Project: PRA-ROCR 10(5)
The purpose of this Amendment is to:

Amendment No. 0002
Project PRA-ROCR 10(5)
Rock Creek Park
Solicitation: DTFH71-16-R-00001

Project Name: Beach Drive from Rock Creek Parkway to Maryland State Line

AMENDMENT NO. 2 ◇1	PMIS NO.	NPS NO.	STATE	PROJECT	SHEET NO.
	044965	821 / 100425	DC	PRA-ROCR 10(5)	D51

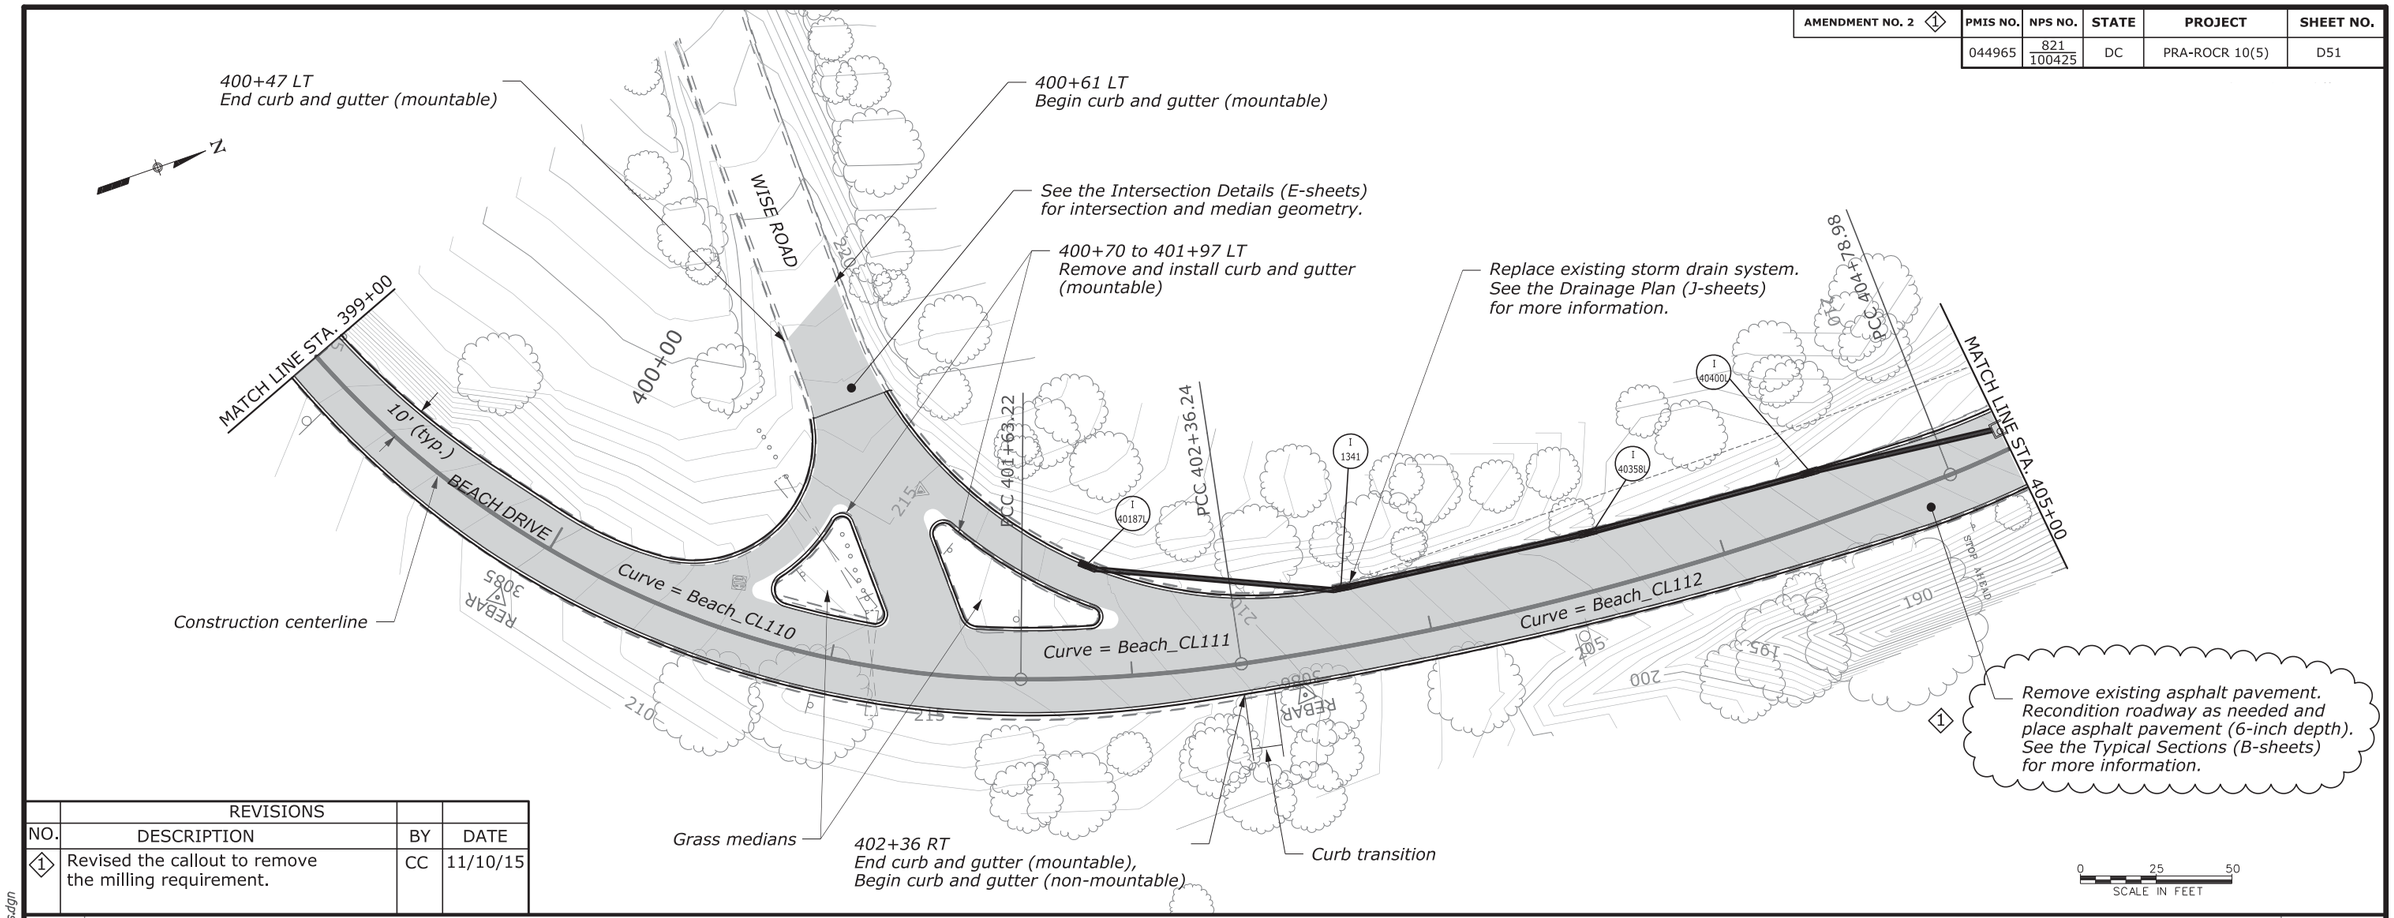
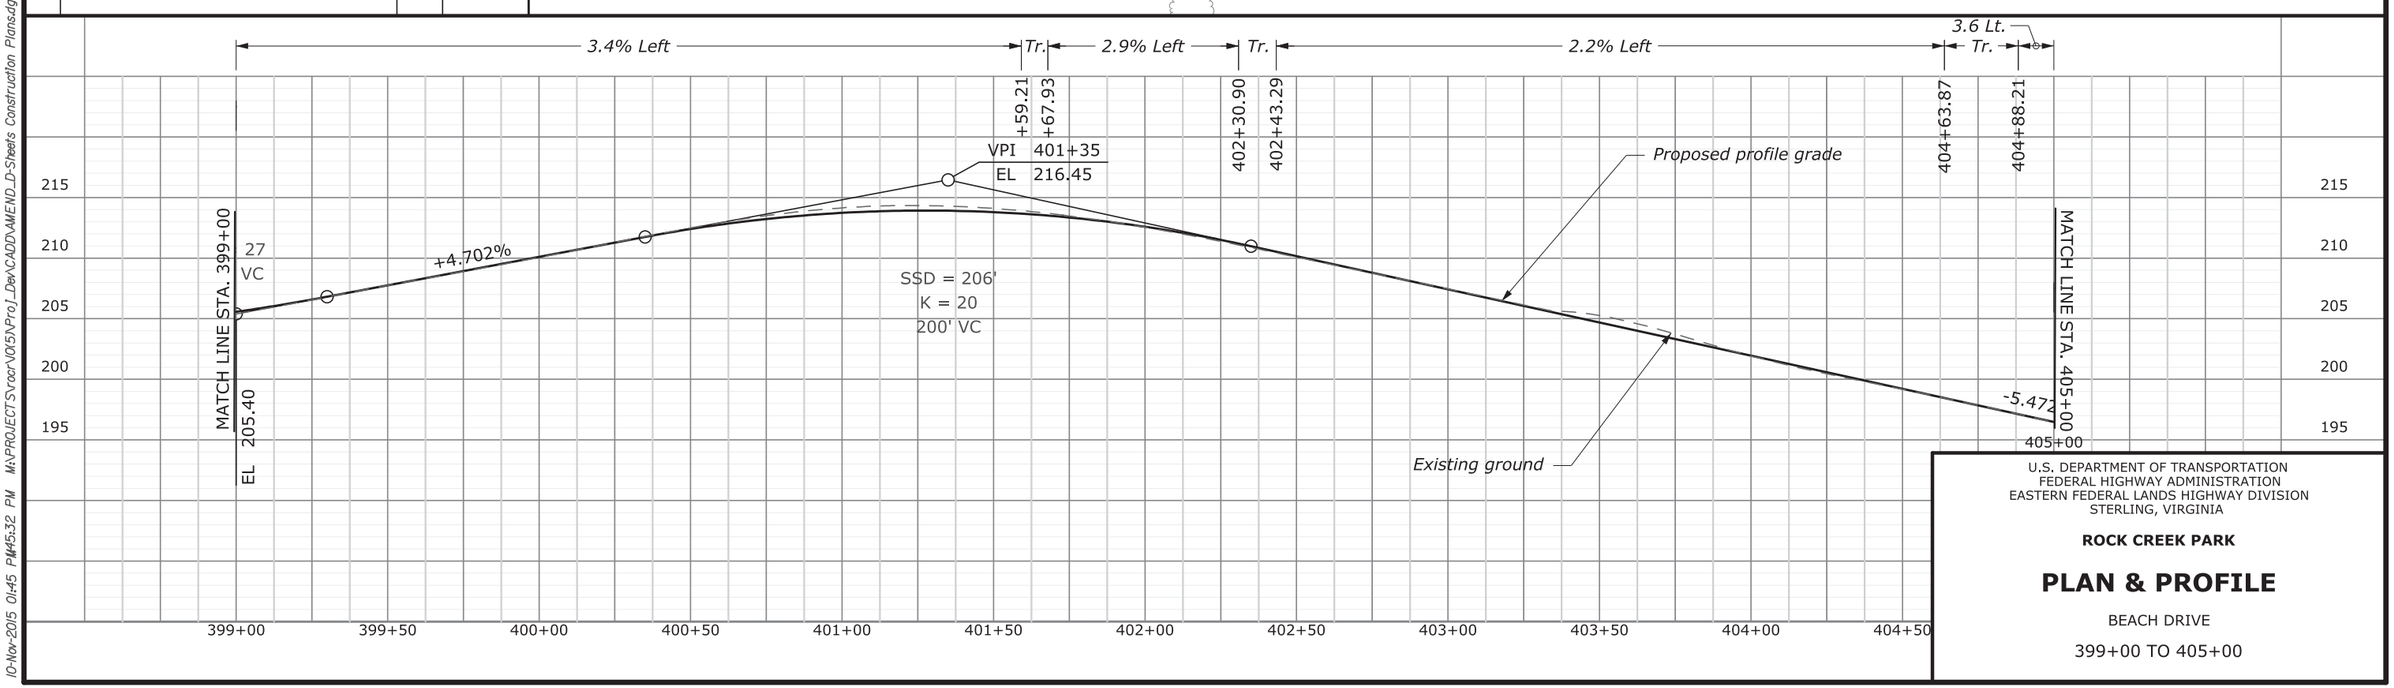
REVISIONS			
NO.	DESCRIPTION	BY	DATE
◇1	Revised the callout to remove the milling requirement.	CC	11/10/15

AMENDMENT NO. 2 ◇1	PMIS NO.	NPS NO.	STATE	PROJECT	SHEET NO.
	044965	821 / 100425	DC	PRA-ROCR 10(5)	D52

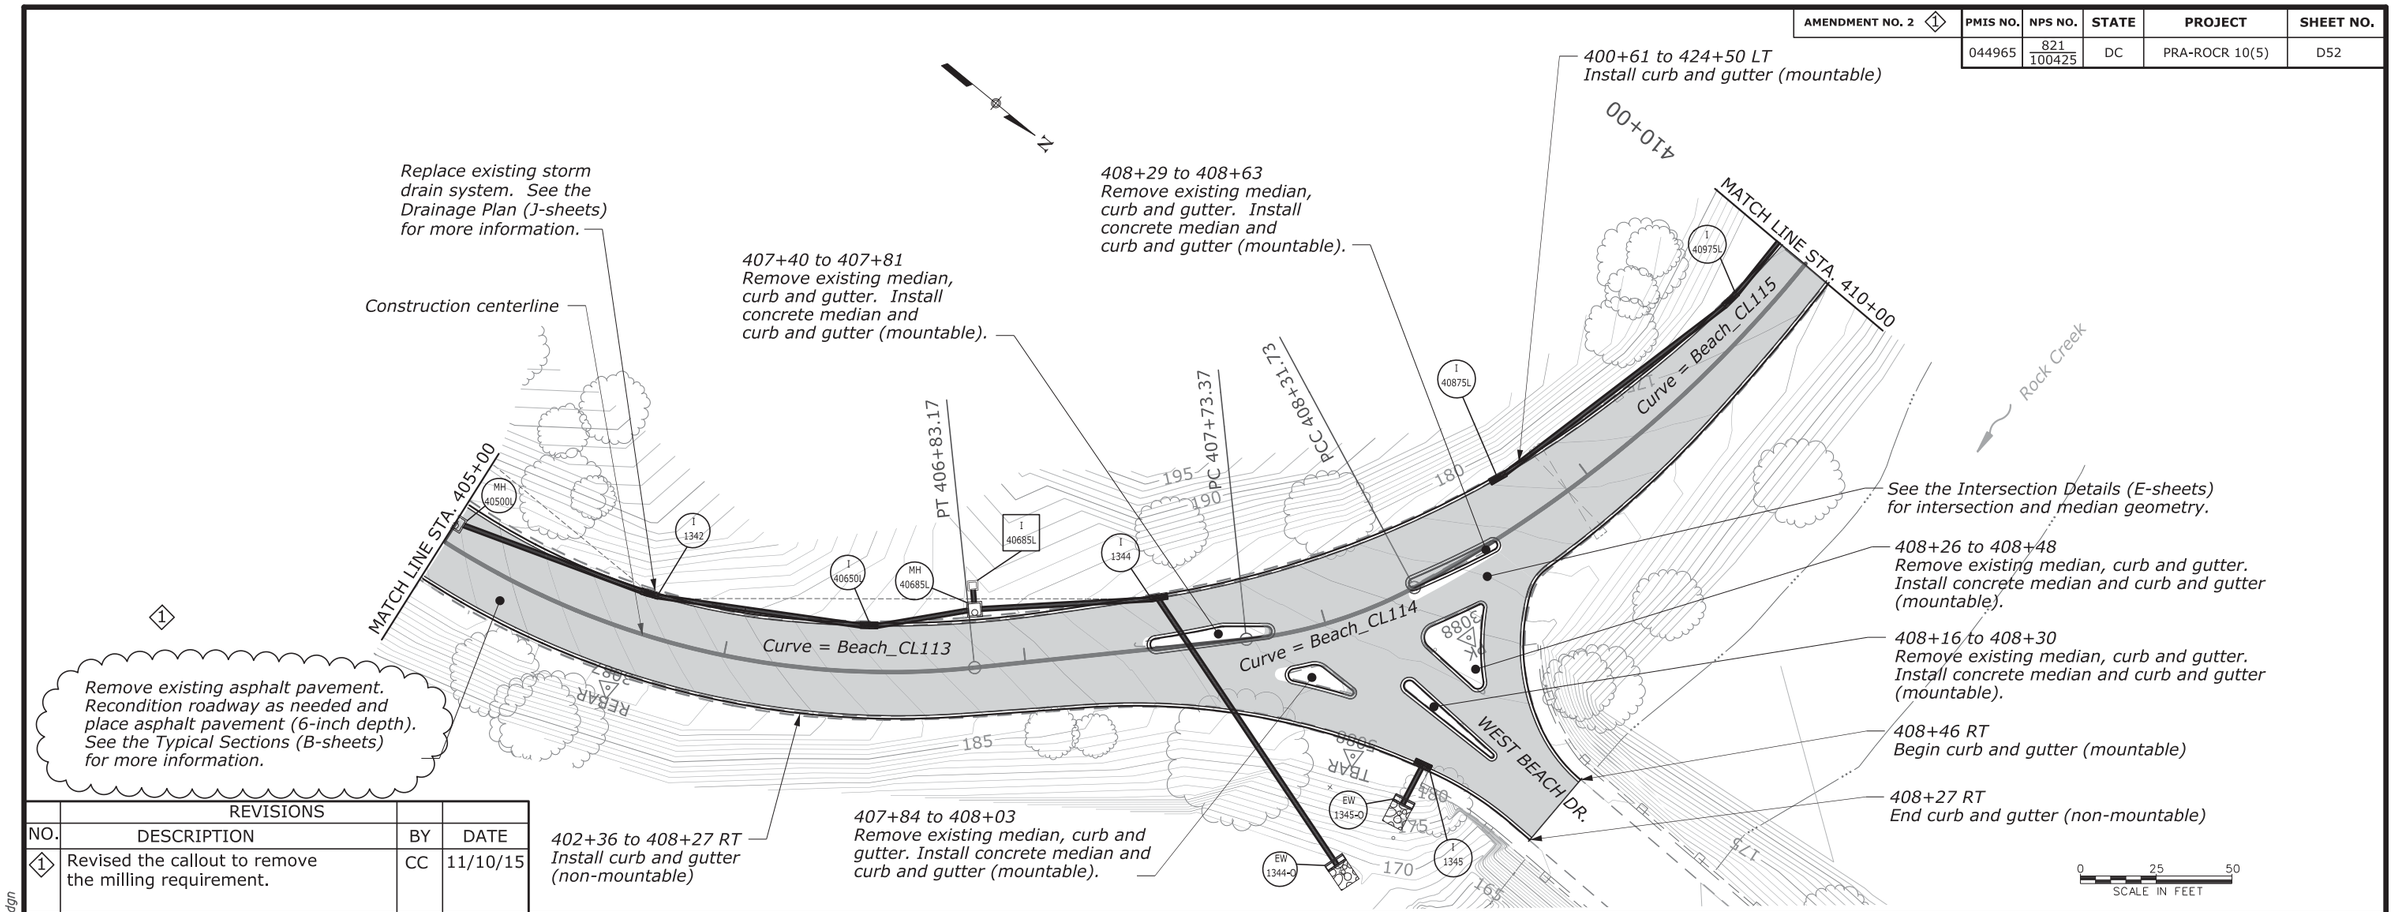
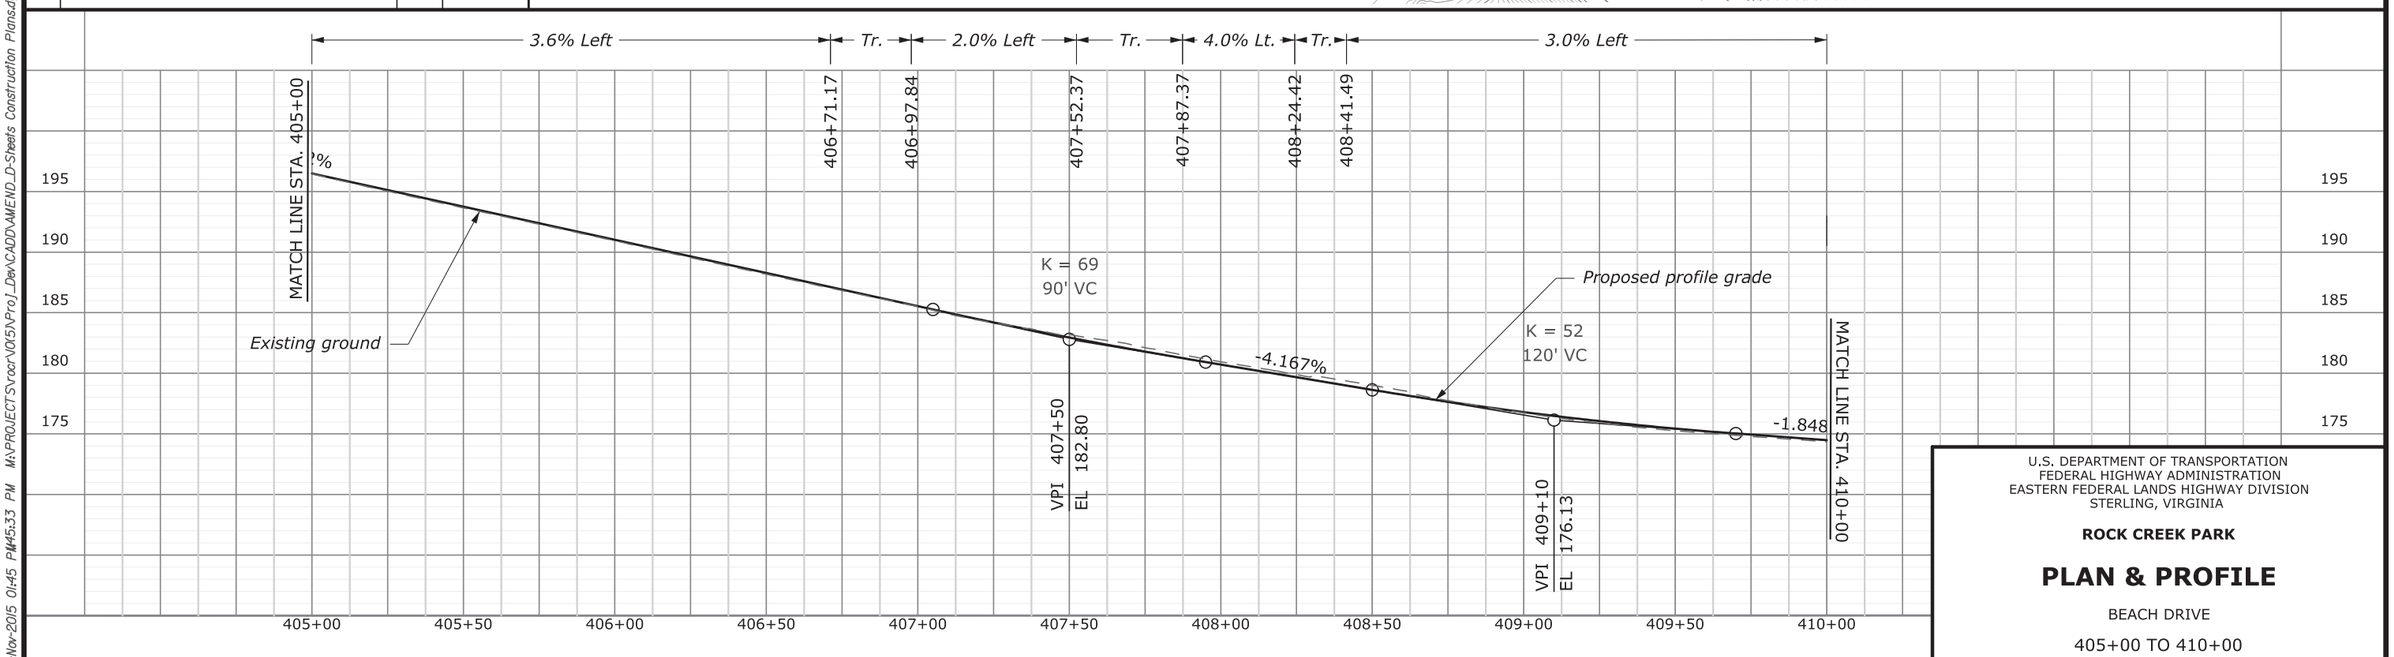
REVISIONS			
NO.	DESCRIPTION	BY	DATE
◇1	Revised the callout to remove the milling requirement.	CC	11/10/15

AMENDMENT NO. 2 ◇1	PMIS NO.	NPS NO.	STATE	PROJECT	SHEET NO.
	044965	821 / 100425	DC	PRA-ROCR 10(5)	D53

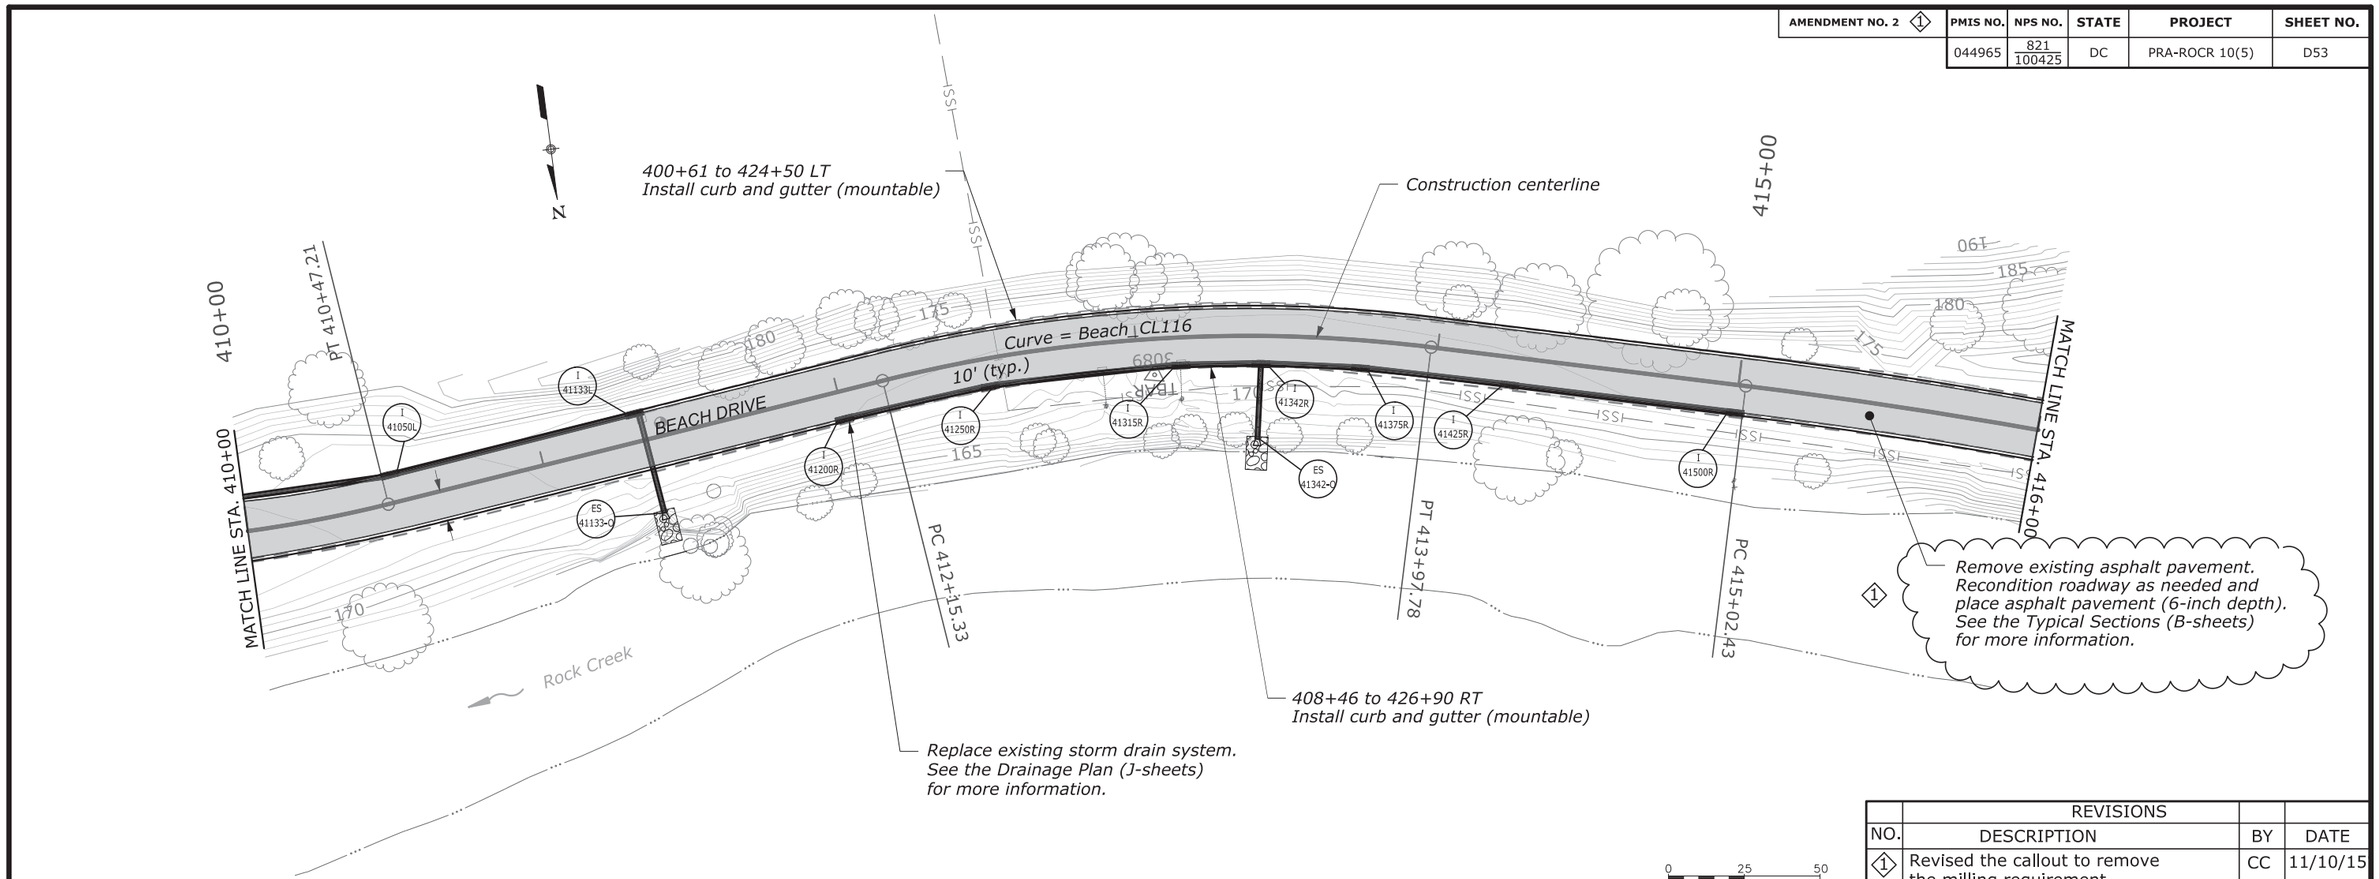
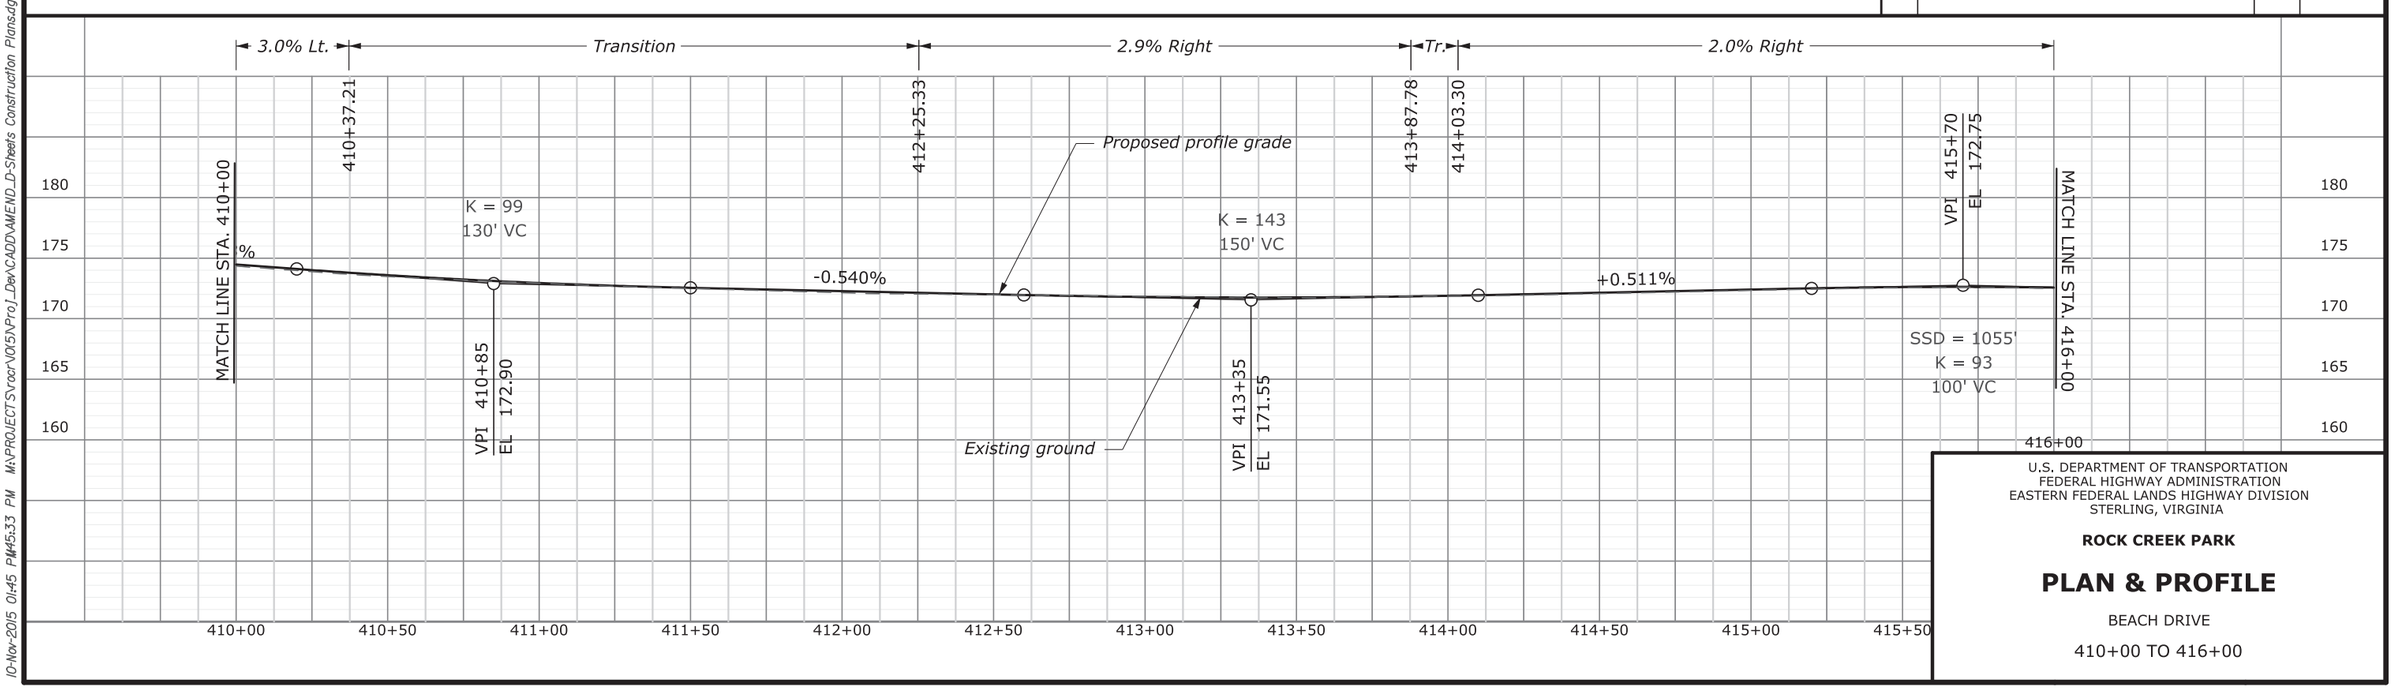
NO.	REVISIONS DESCRIPTION	BY	DATE
◇1	Revised the callout to remove the milling requirement.	CC	11/10/15
